Addendum No. 4

Date: February 28, 2012

PROJECT: Long Branch – George L. Catrambone Elementary School

CONTRACT No.: ET-0068-C01

2 TYP ALUMINUM WINDOW SILL DETAIL
 A-5.5 SCALE: 6" = 1'-0"

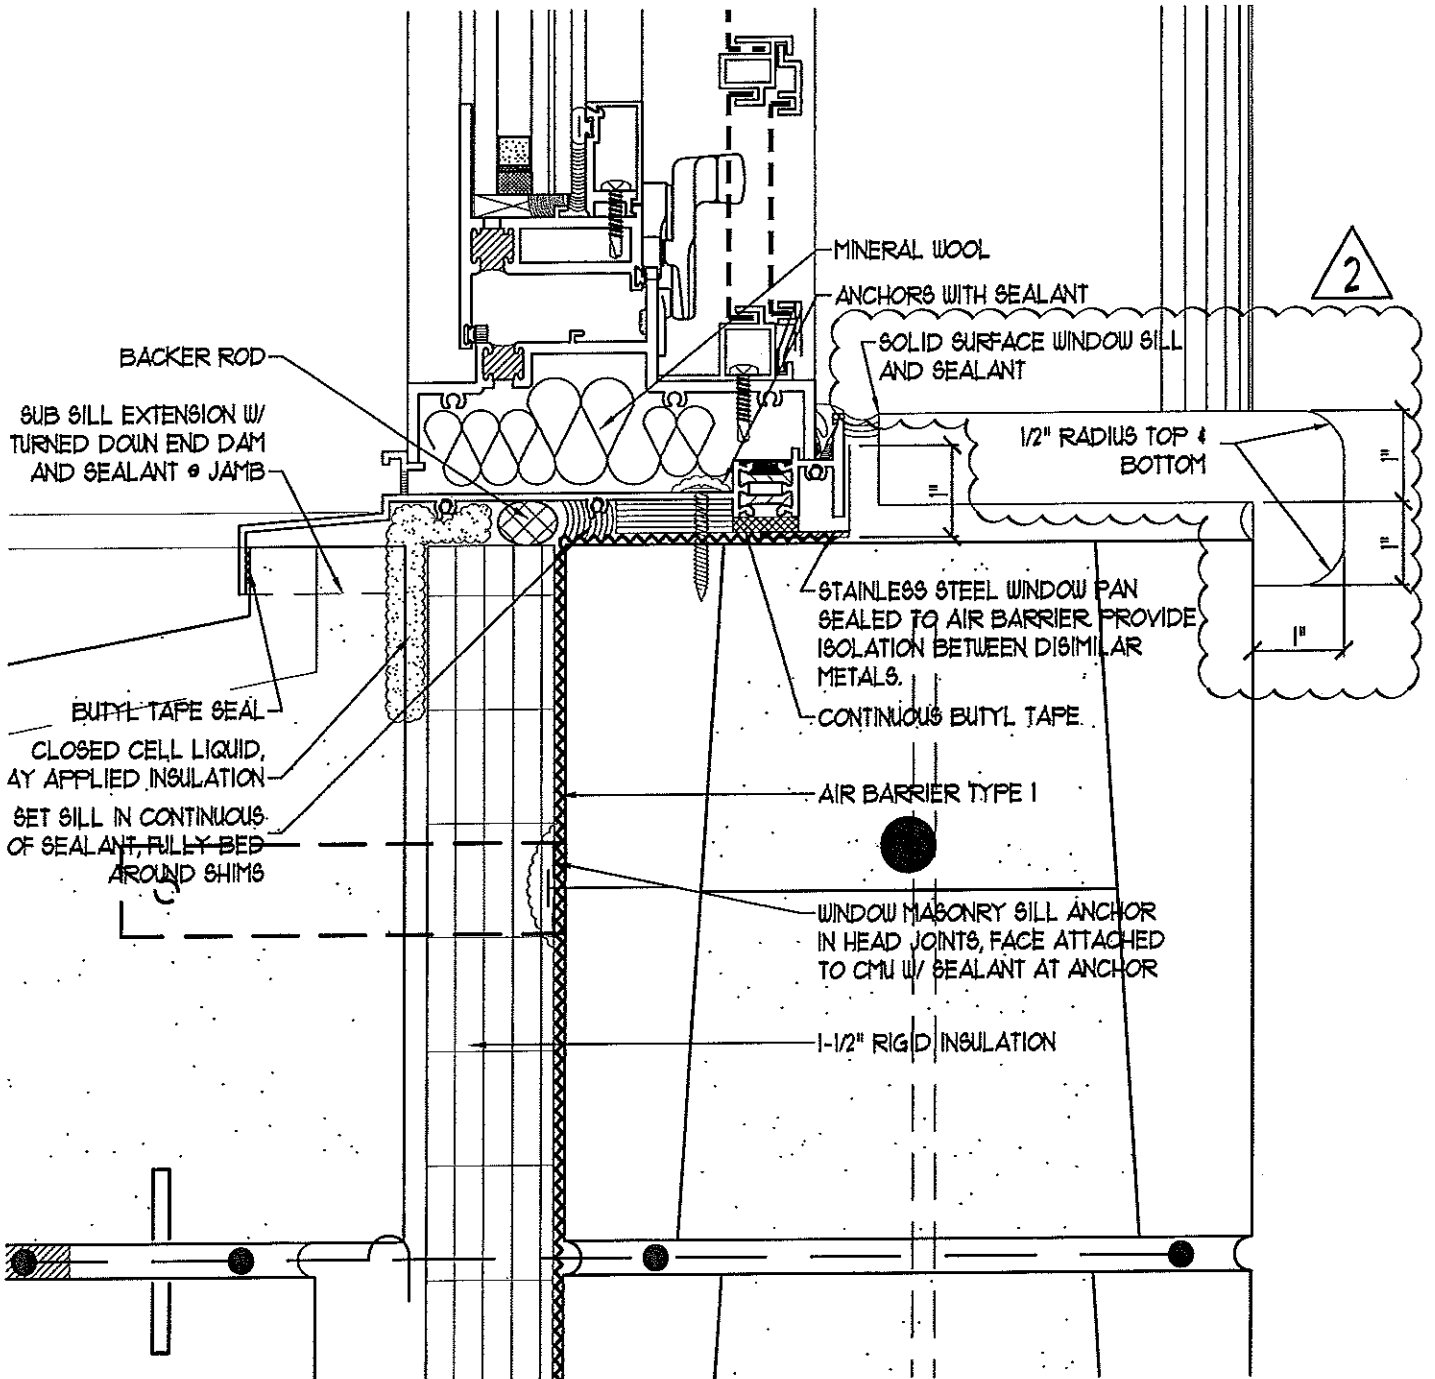
- Detail 2/A-5.5:
 - Revise window sill per SK-33. This detail applies to all solid surface windows sills.

REFERENCED DRAWING
 DETAIL/SHEET # 9/A-6.4
 DATE: 10-20-11

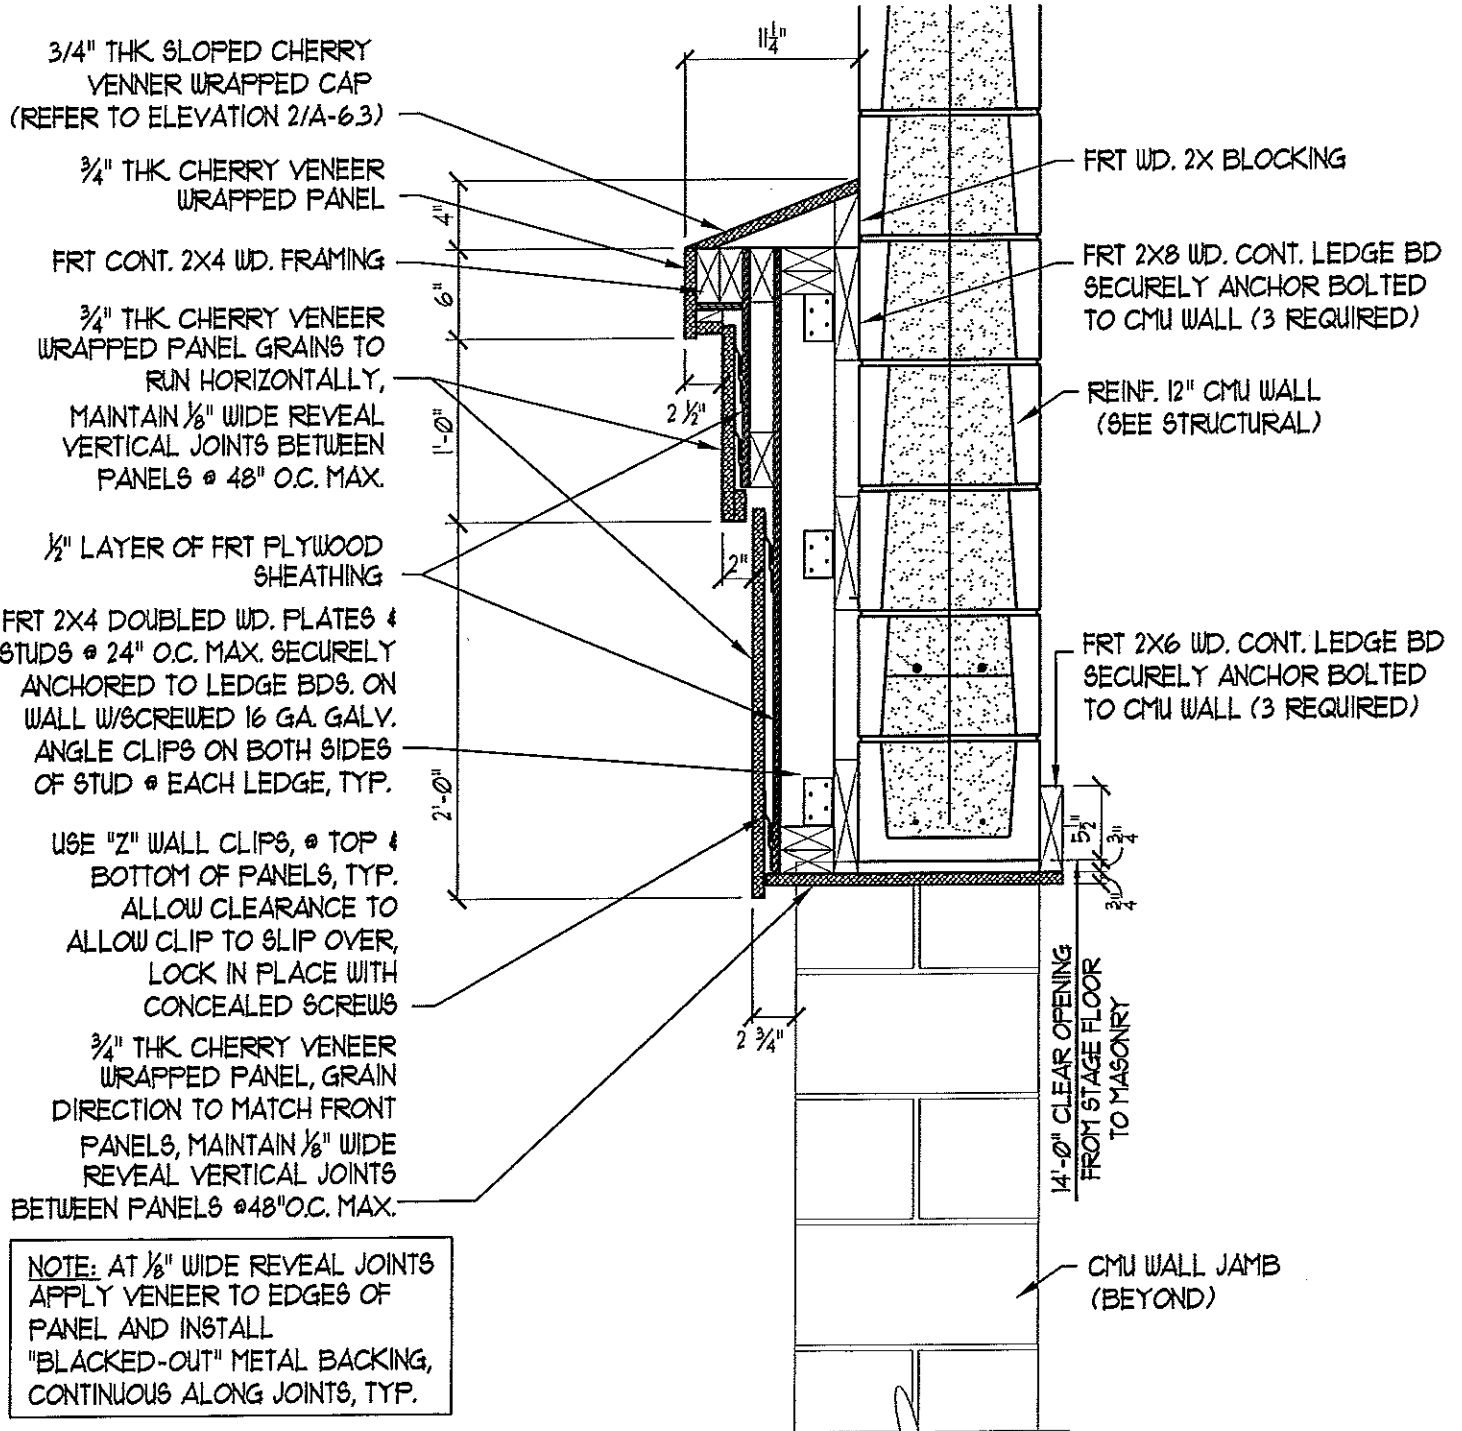
- Detail 7/A-6.4:
 - Add secondary handrail. Refer to Detail 11/A-6.6 for railing type, mounting height and mounting details.
- Detail 9/A-6.2:
 - Revise detail per SK-34.

REFERENCED DRAWING
 DETAIL/SHEET # 2/S-2.14
 DATE: 10/20/11

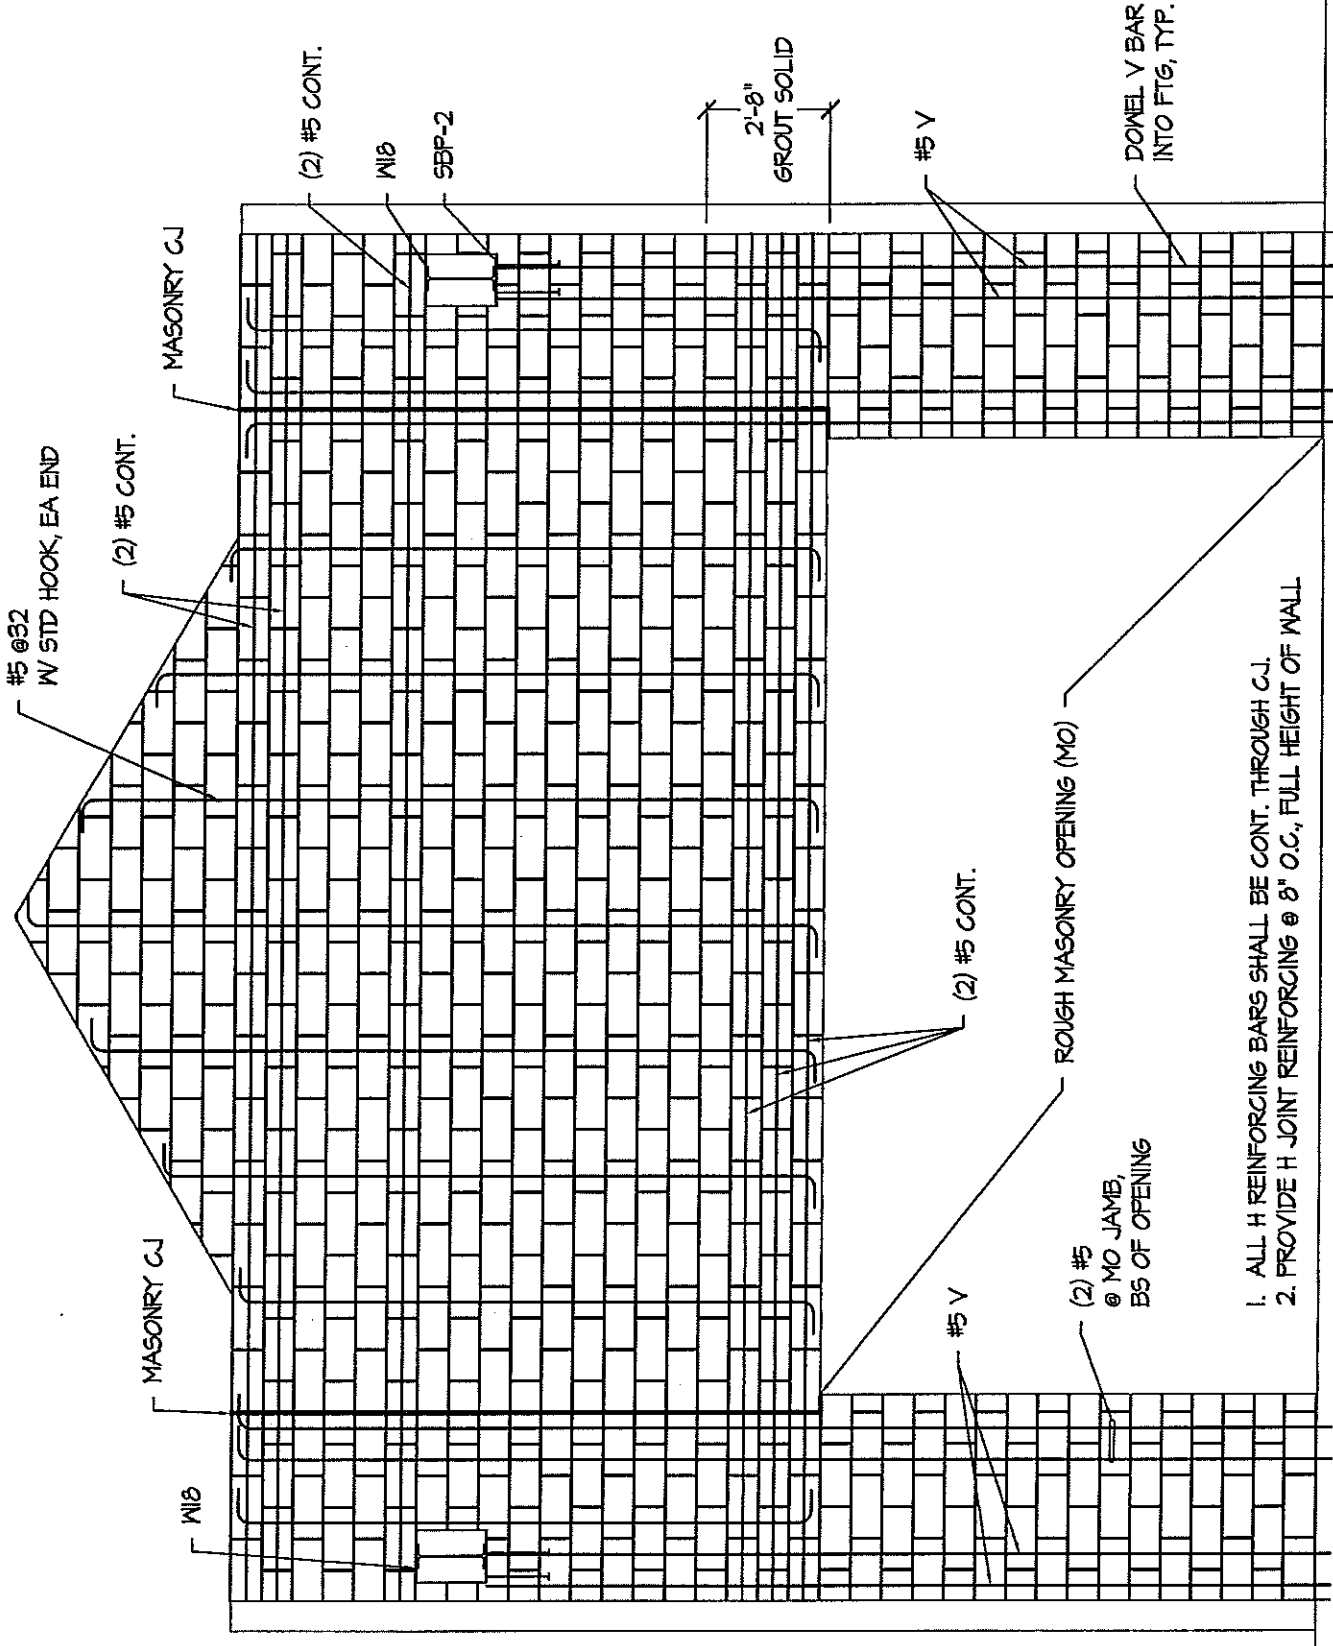
- Detail 2/S-2.14, Sketch SK-S-1:
Replace detail 2/S-2.14 as shown in attached Sketch SK-S-1.
- First Floor & Foundation Plan – Block "D", 1/S-2.14, Sketch SK-S-2:

REFERENCED DRAWING
DETAIL/SHEET # 1/S-2.21
DATE: 10/20/12

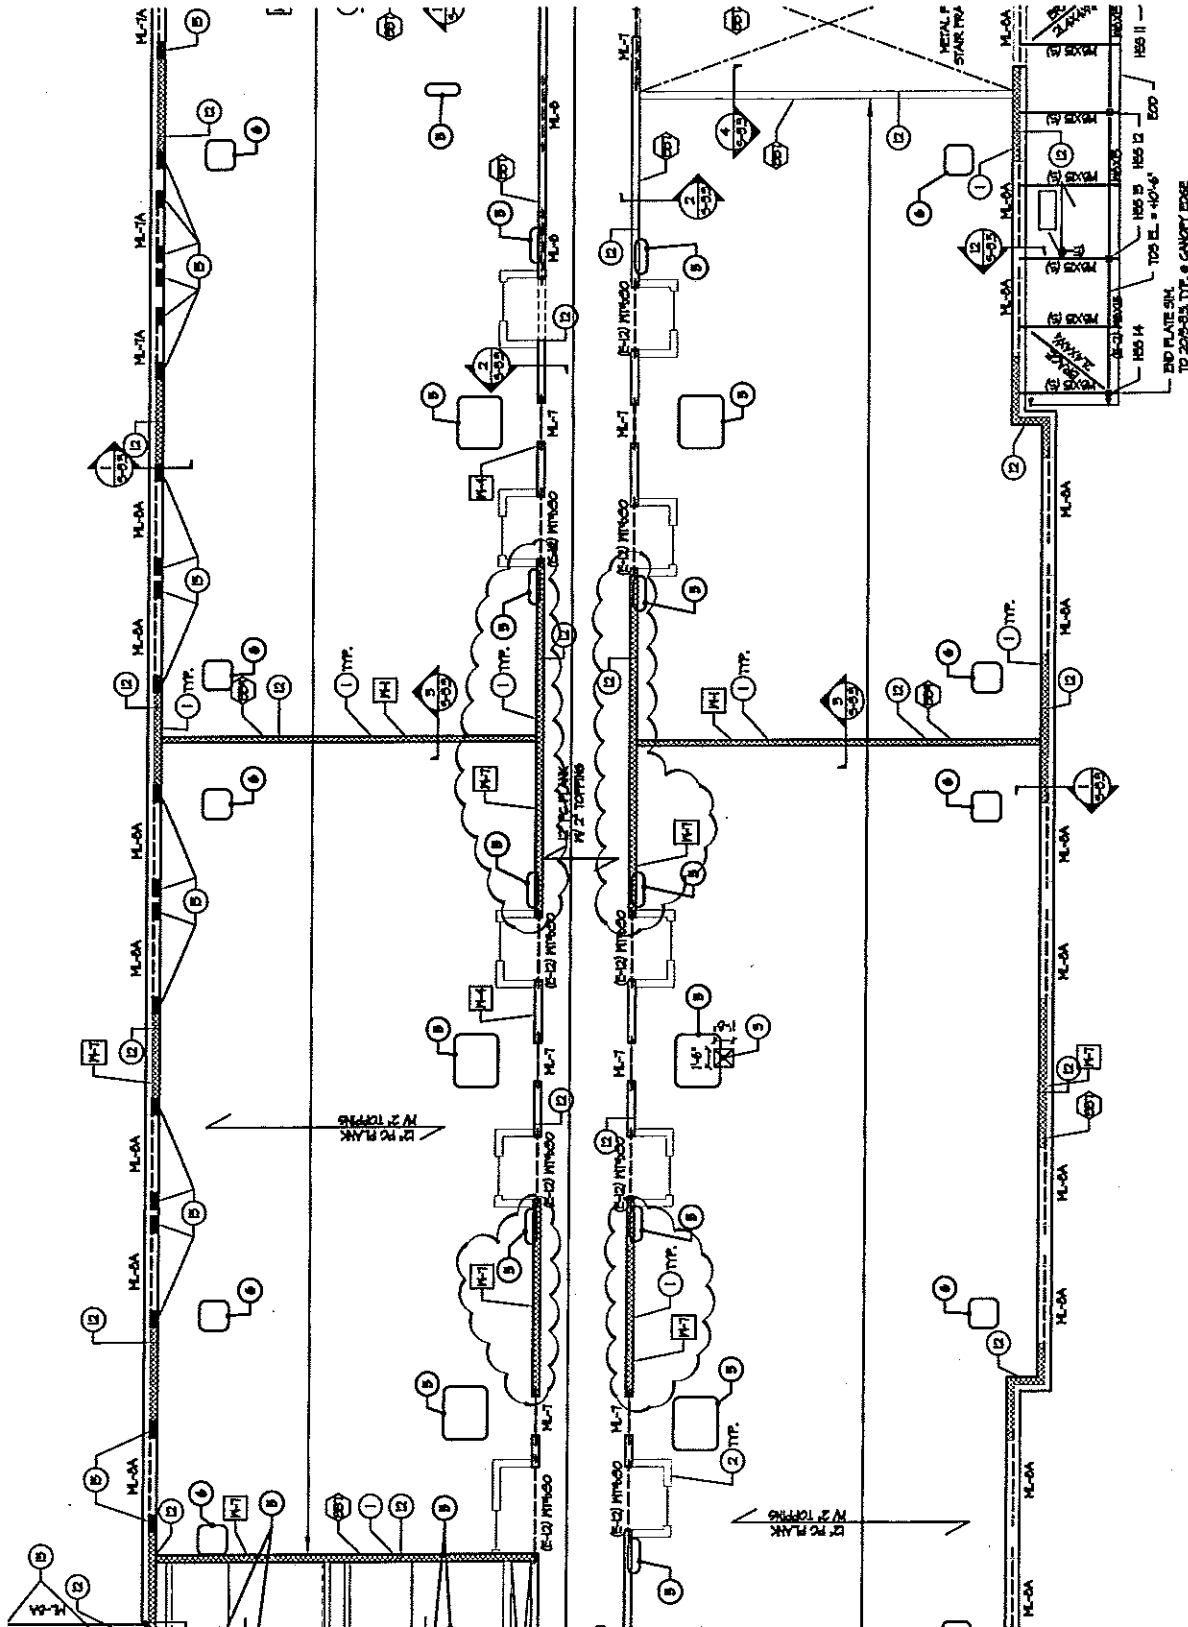
- Second Floor Framing Plan – Block “E”, 1/S-2.21:
Add bond beam designation BB-13 (+12’-8”) at Elevator shaft 12” CMU wall and BB-7 (+12’-8”) at 8” CMU Elevator walls. Bond beam reinforcing shall be continuous around elevator shaft. Provide additional bond beam at each elevator rail bracket. Contractor to obtain final rail bracket locations from elevator manufacturer.
- Second Floor Framing Plan – Block “E”, 1/S-2.21:
Provide ML-9 at head of elevator pit ladder wall recess.
- Second Floor Framing Plan – Block “E”, 1/S-2.21, SK-S-3:
Revised reinforcing for shear walls at second floor to roof elevation, as shown hatched on attached SK-S-3.

12A DETAIL
 S-3.5 SCALE: 3/4"=1'-0"

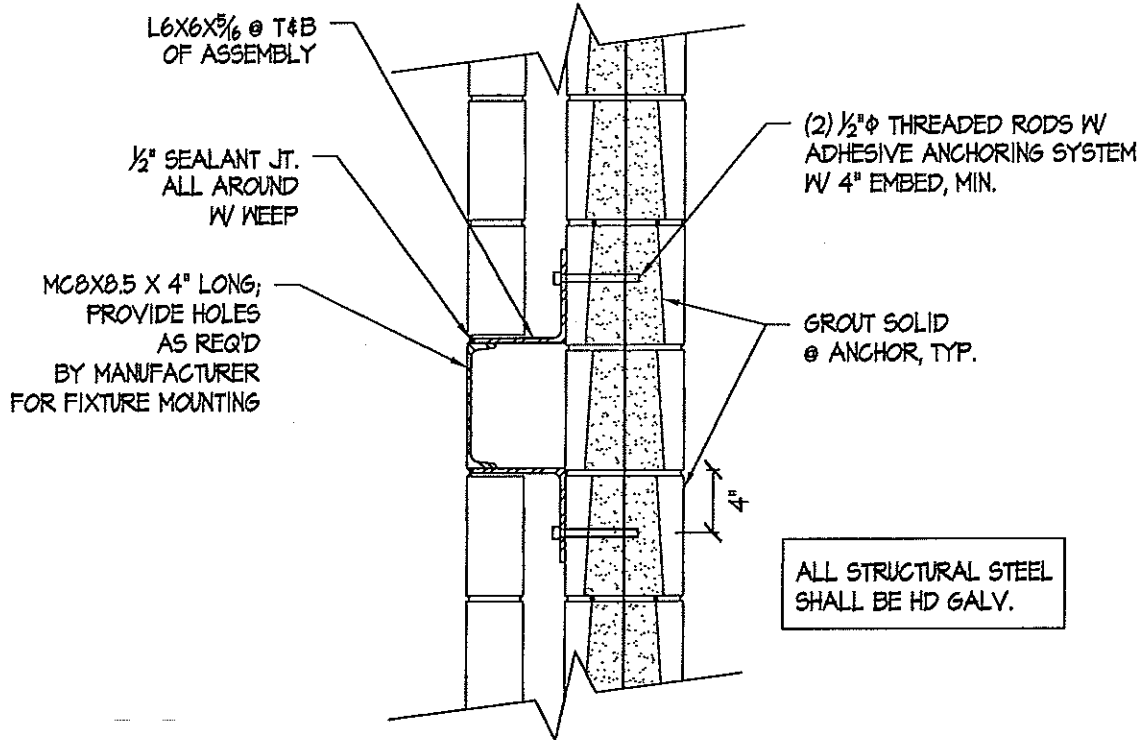
- 'Exterior Fixtures Legend'
 - Add fixture note as follows "PROVIDE TYPICAL WALL ANCHORAGE FOR ARM & ROD TYPE EXTERIOR LIGHT FIXTURE AS INDICATED ON DETAIL 12A/S-3.5. COORDINATE WITH THE FIXTURE MANUFACTURER'S RECOMMENDED INSTALLATION INSTRUCTIONS." Refer to SK-S-8 for detail.
